REVISED RESPONSE TO REQUEST FOR ADDITIONAL INFORMATION

APR1400 Design Certification

Docket No. 52-046

RAI No.: 470-8552
SRP Section: 16 – Technical Specifications
Application Section: 16.3.3.1
Date of RAI Issue: 26/04/2016

Figure 7.2-11

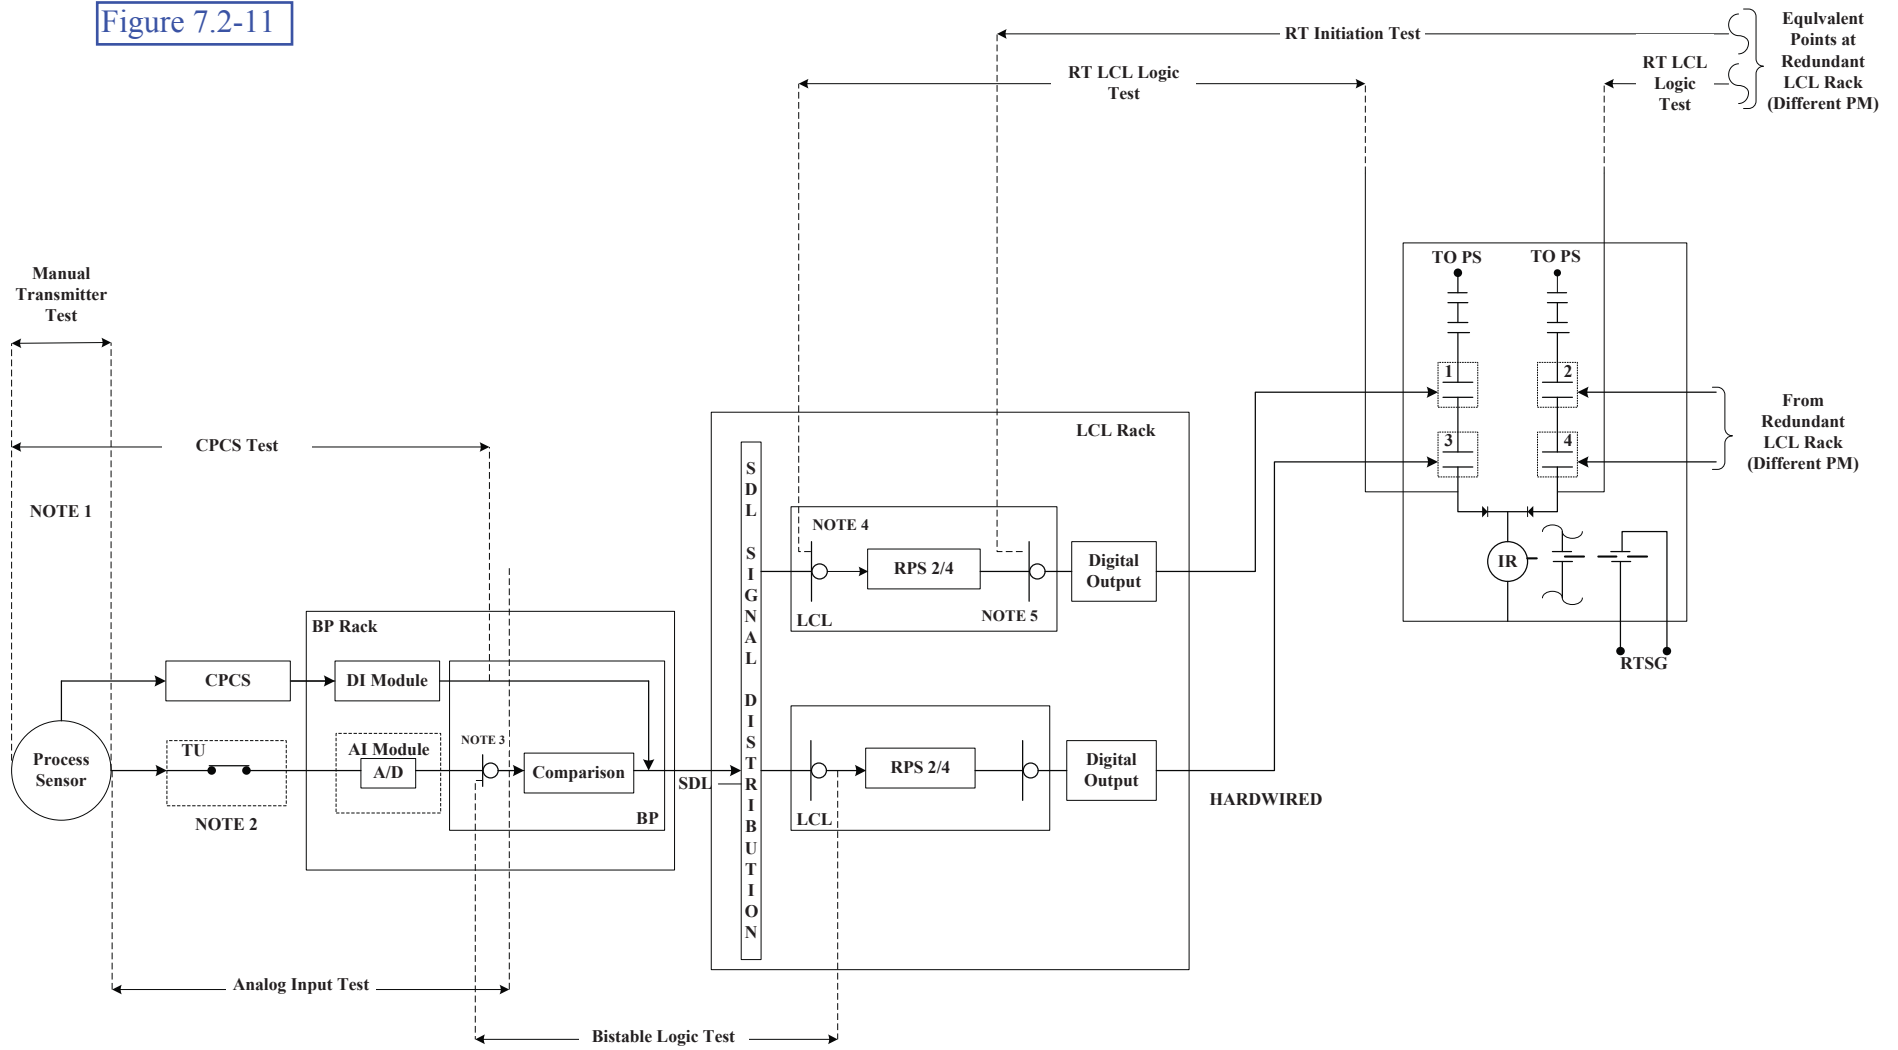
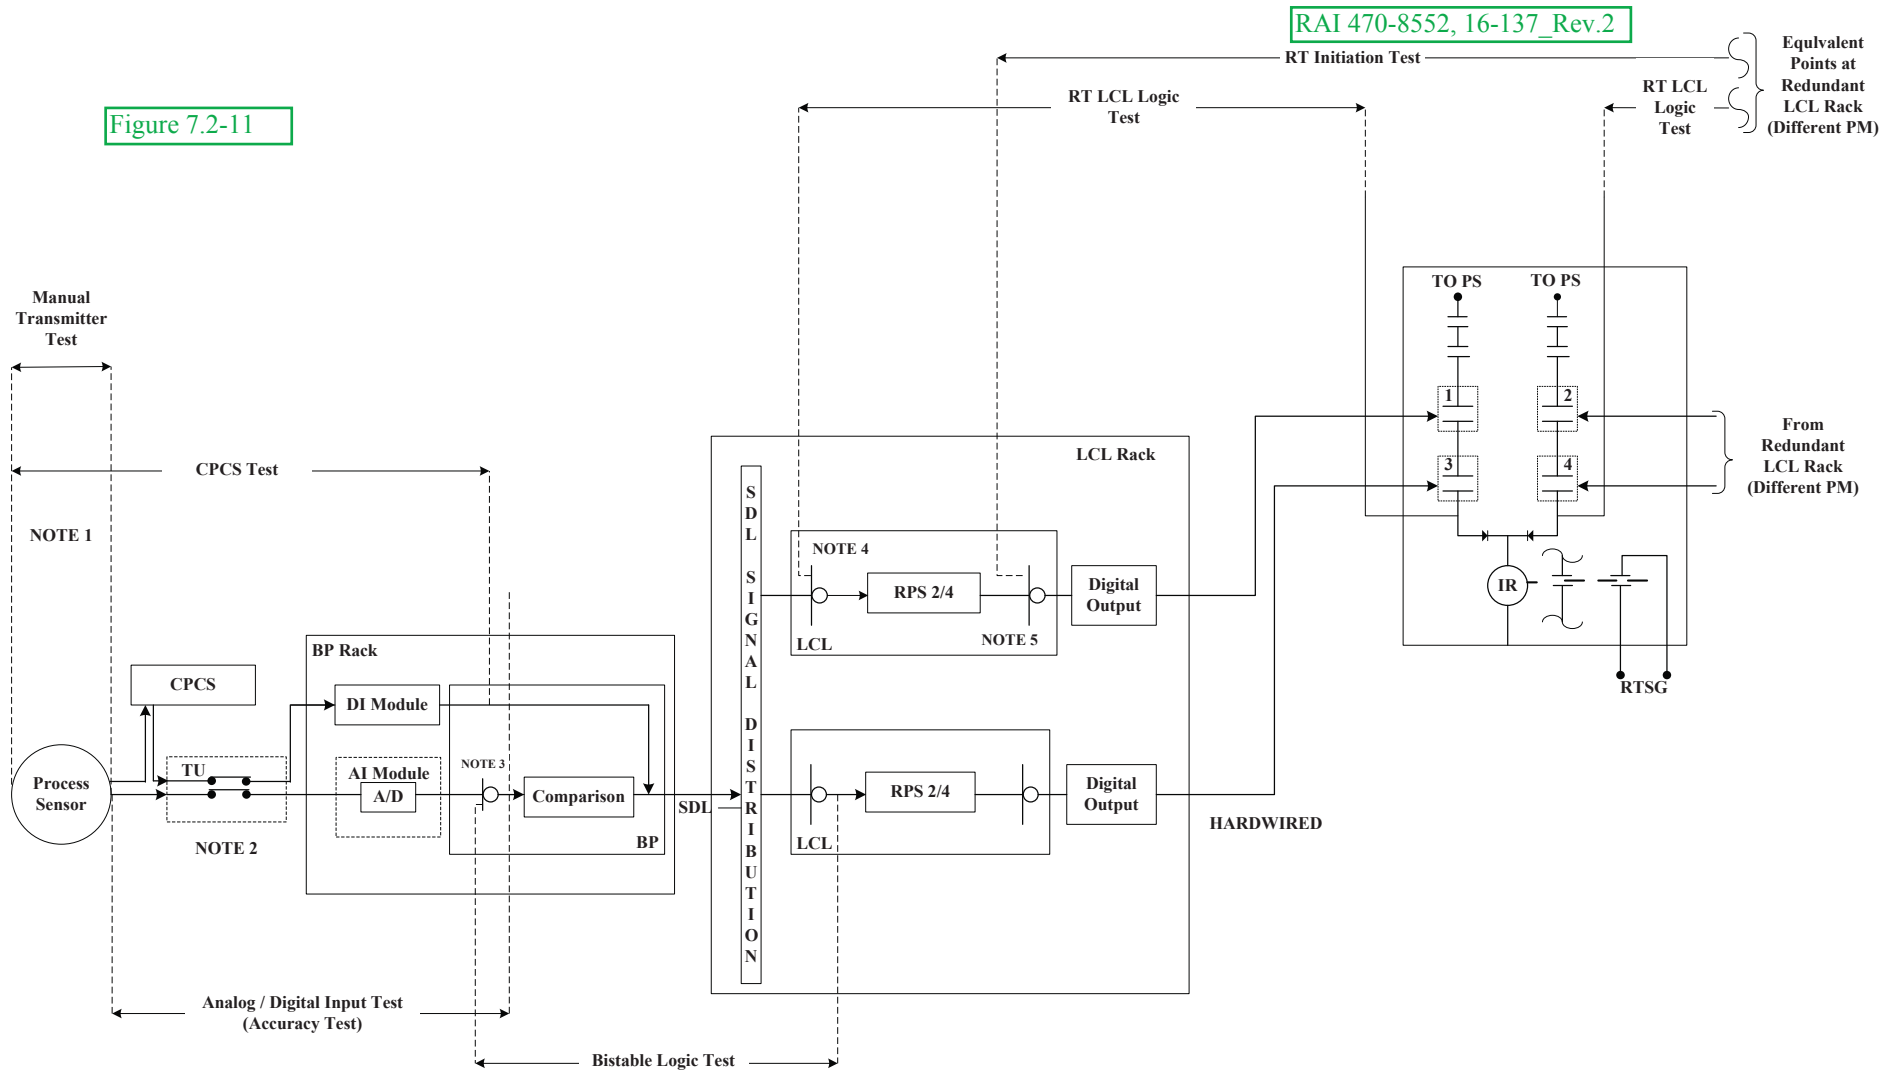
2. Notice that DCD Figure 7.2-11 does not depict "CPCS Test" and "Manual Trip Test", which are described in DCD Section 7.2.2.5. The applicant is requested to revise DCD Tier 2 Section 7.2 so that Section 7.2.2.5 and Figure 7.2-11 are correctly aligned. In addition, consider adding a discussion in DCD Tier 2 Section 7.3 that describes the testing for the ESFAS instrumentation loops with the same level of detail as the requested revised description in DCD Tier 2 Section 7.2.2.5, and also a figure equivalent to Figure 7.2-11. Notice that Figure 7.2-11 depicts no tests for ESFAS related components after the input to the actuation logic in the group controller.

4. The applicant is requested to explain what meaning the "OR" logical gate symbols on Figure 7.2-11 are intended to convey; especially with respect to depicting testing overlap. The requested information is needed to enable the NRC staff to determine whether or not surveillances for RPS and ESFAS instrumentation functions satisfy 10 CFR 50.36 requirements.

1. Table 1 is prepared based on DCD Tier 2 Figure 7.2-11, which shows the testing overlap for the periodic manual tests required to verify the integrity of the RPS functions during power operation of the plant. The component names and descriptions in the figure are identified by relationship with the testing type provided in DCD Tier 2 Section 7.2.2.5, "System Testing and Inoperable Surveillance". Additionally, the "CPCS" and "CPCS test" will be included in DCD Tier 2 Figure 7.2-11.

2. The missing information of CPCS and CPCS Test in DCD Tier 2 Figure 7.2-11 will be added.

The logical OR symbols on Figures 7.2-11 and 7.3-24 will be explained in DCD Tier 2, In Figure 7.2-11, the logical OR in the receiving stage of bistable processor (BP) indicates that the downstream logic processes either the actual process input signal or the simulated test input signal. The logical OR in the receiving stage of LCL indicates that local coincidence logic (LCL) logic is processed either by the actual signal or by the test signal. The logical OR in the transmitting stage of LCL or the receiving stage of the digital output module indicates that the digital output module generates the output either by the actual signal or by the test signal.

DCD Tier 2 Figure 7.2-11 will be revised as indicated in the attachment associated with this response.
